DATE: 04.18.2018
TO: ProTrak
FROM: Mitesh Baxi
Traffic Engineering

■ **MIKE'Z EXPRESS CARWASH [TRC Plan Review]**

Initial Review Note

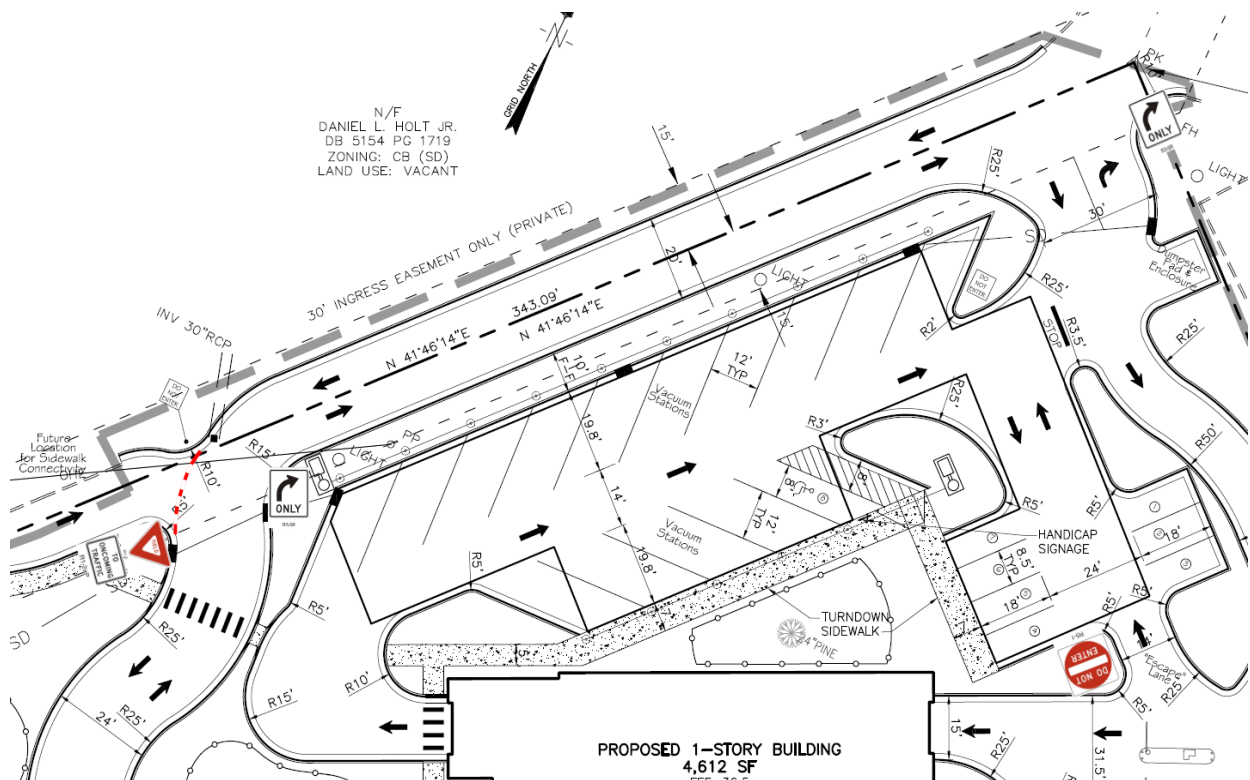
1. Driveways along major thoroughfare Carolina Beach Rd must at least 75' offset from property lines to the curb line. A variance may be required.
